ENGINEERINGUPDATE

NO:	SW - 118
DATE:	March 2017

PRODUCT: D2D and D2T – Door Switch TYPE: Modification – UL Standard and Marking Change

## D2D and D2T Door Switch - UL Standard and Marking Change In accordance to UL Standard transition from UL1054 to UL61058-1

## D2D-2000 Model Detail of Changes - Marking:

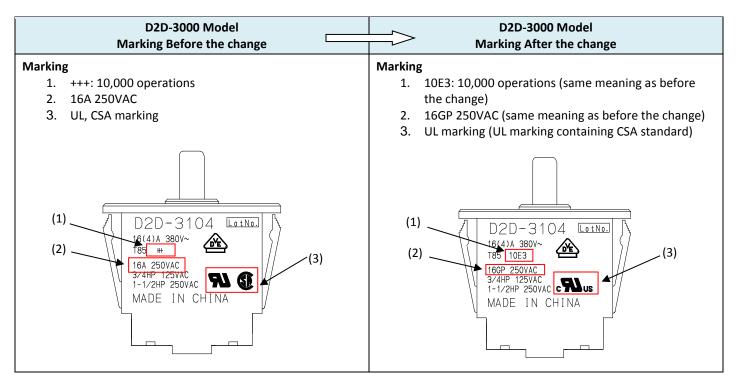
D2D-2000 Model Marking Before the change	D2D-2000 Model Marking After the change
Marking 1. 1E4: 10,000 operations 2. 10A 250VAC 3. UL, CSA marking	<ul> <li>Marking</li> <li>1. 10E3: 10,000 operations (same meaning as before the change)</li> <li>2. 10GP 250VAC (same meaning as before the change)</li> <li>3. UL marking (UL marking containing CSA standard)</li> </ul>
(1) (2) (1) (2) (2) (1) (2) (1) (2) (2) (1) (2) (2) (2) (2) (3) (3) (3) (3) (3) (3) (3) (3	(2) (1) (2) (1) (2) (1) (2) (1) (1) (2) (1) (1) (2) (1) (2) (1) (1) (2) (1) (2) (1) (1) (2) (2) (1) (2) (2) (2) (2) (2) (2) (2) (2
